Memorandum

To: Planning Commission

From: Pedestrian Bicycle Advisory Committee

Subject: Southeast Redmond Neighborhood Plan Update

**SE Redmond Neighborhood Plan Update
PBAC Recommendations**

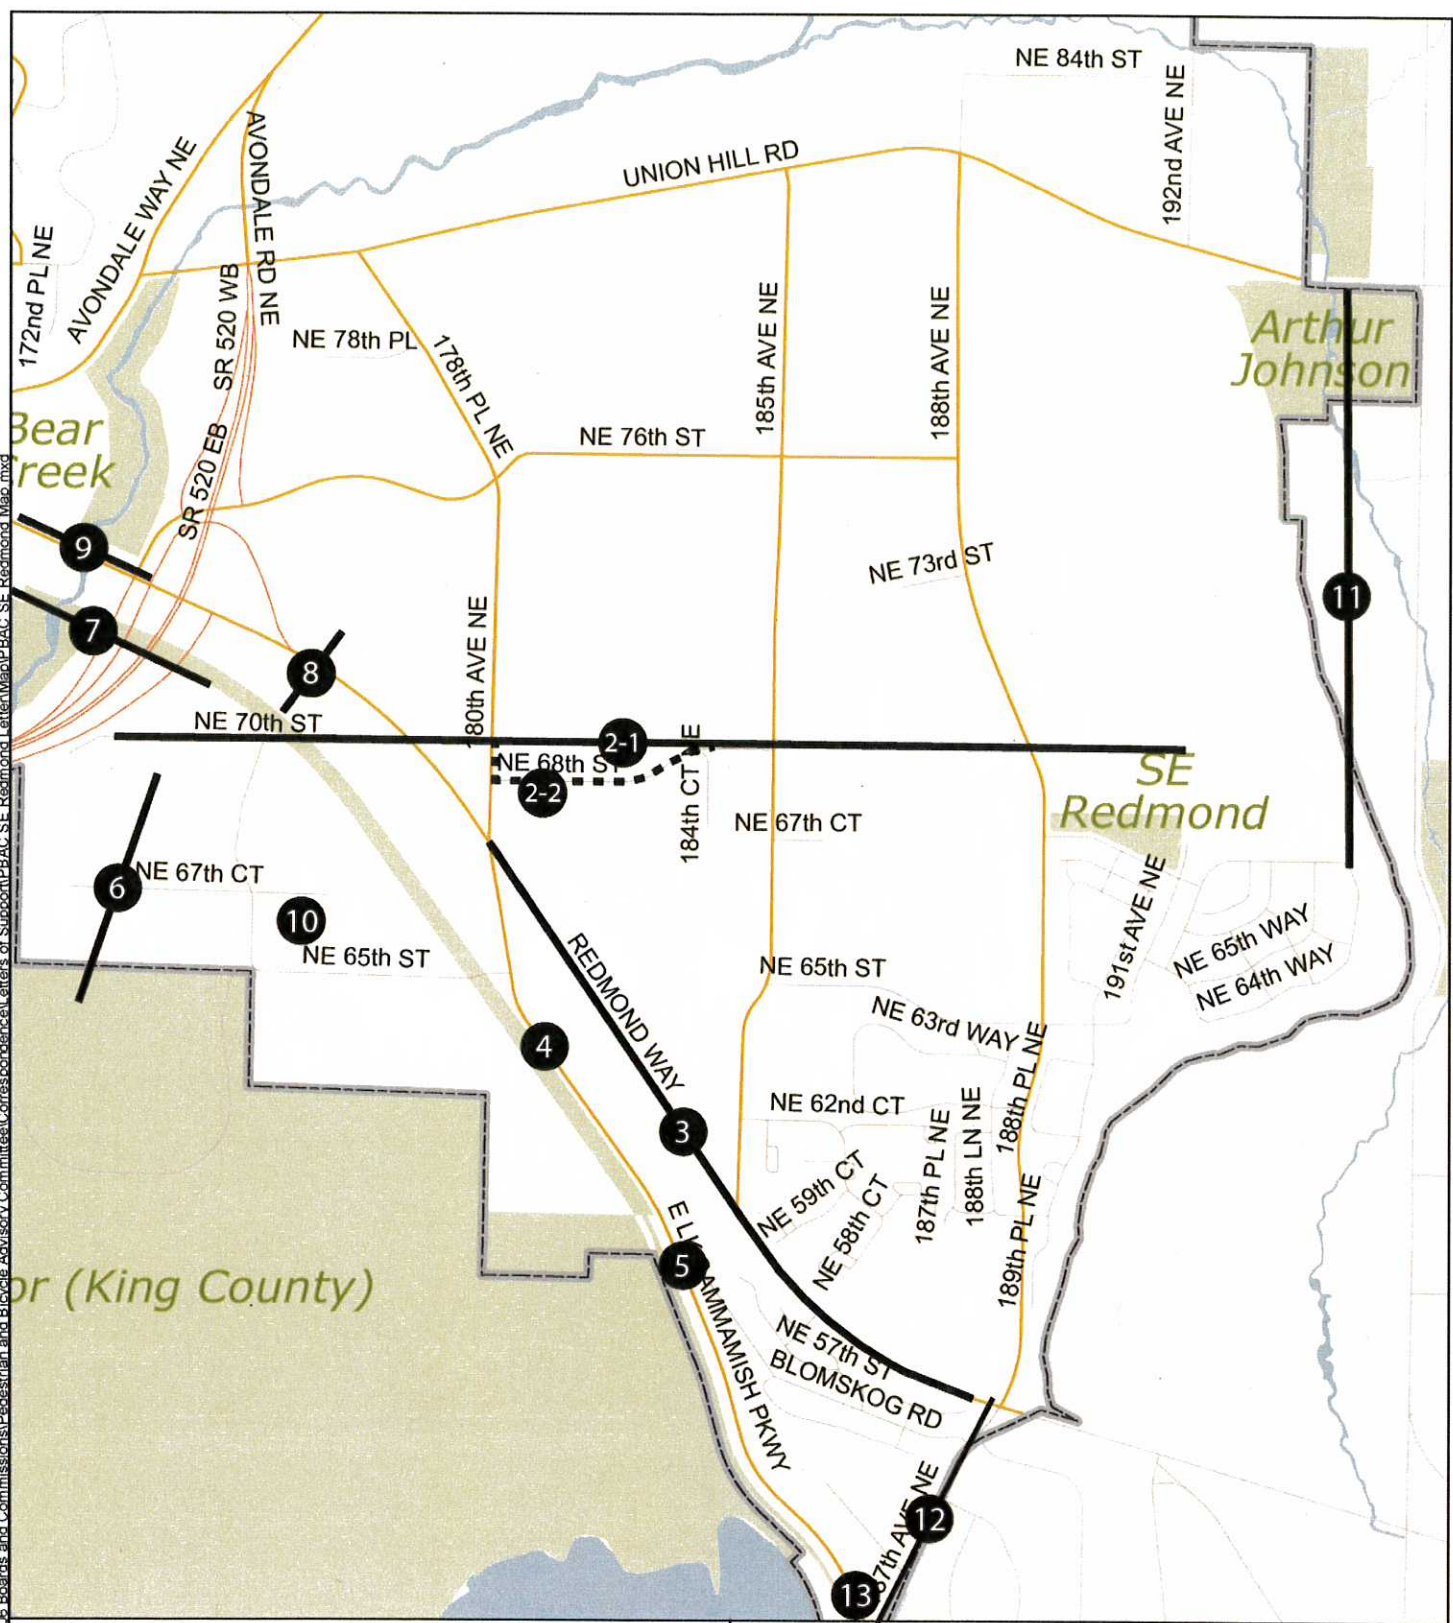
1. Complete the street grid system so that pedestrians and bicyclists can use the most convenient and shortest routes.
2. Incorporate high comfort bicycle facilities such as cycle tracks or additional paved shared-use paths for a new or improved East-West connection – current plans only include high comfort bicycle facilities on edges of the neighborhood, but do not provide a high quality east-west connection between the future light rail station and the housing and employment east of SR 202.

Option 1: Create a new non-motorized connection between 180th Ave and 185th Ave in the vicinity of the 7000 block, creating a complete, comfortable bicycle and pedestrian corridor from the future light rail station to the land uses east of SR 202, all the way to 192nd Ave.

Preferred Option 2: Provide a high quality bicycle and pedestrian connection on 180th Avenue that ties the 70th Street connection from SR 202 to 180th Ave that links to the existing 68th Street at 180th Ave.

In either option, sidewalks should be wider than the standard 5 foot width.

3. Consider another enhanced Pedestrian crossing of Redmond Way between 180th Ave NE and 188th Ave NE.
4. Consider an enhanced Pedestrian crossing of East Lake Sammamish to connect the residential area on the Eastside to the Retail Center/Marymoor Park to the West.
5. Provide a non-motorized connection to East Lake Sammamish Parkway from the English Cove neighborhood. The connection can be provided by extending NE 55th St. The portion that is closed to traffic is already 80-percent paved.

6. There should be a fine-grained network of high comfort non-motorized connections to the light rail station. One important connection is to Marymoor Park.

7. Keep a strong emphasis on the completion of the East Lake Sammamish Trail thru the SR520 Interchange (grade separated) to the Redmond Central Connector.

8. We support a grade separated crossing of Redmond Way.
9. Add a new separated Bicycle/Pedestrian facility along the North side of Redmond Way at the crossing of Bear Creek. This would tie the existing WSDOT trail to the Bear Creek Trail and allow connections between the Redmond Central Connector to the East Lake Sammamish Trail prior the completion of item 2. East Lake Sammamish Trail completion through the SR 520 Interchange (grade separated) which is currently envisioned to occur at the same time that light rail is extended into Downtown (min 20 years away). Item 2 remains a critical project that directly links three regional paved, shared use paths.

11. Keep emphasizing and if possible complete the extension South of the Evans Creek Trail through Arthur Johnson Park and to the existing trail near 195th Pl NE.

12. Provide bicycle lanes or separated bikeway along 187th Ave NE between SR202 and East Lake Sammamish Parkway and the East Lake Sammamish trail.
13. At East Lake Sammamish and 187th Ave NE, upgrade the existing under crossing to ADA standards to allow easy pedestrian and bicycle access.
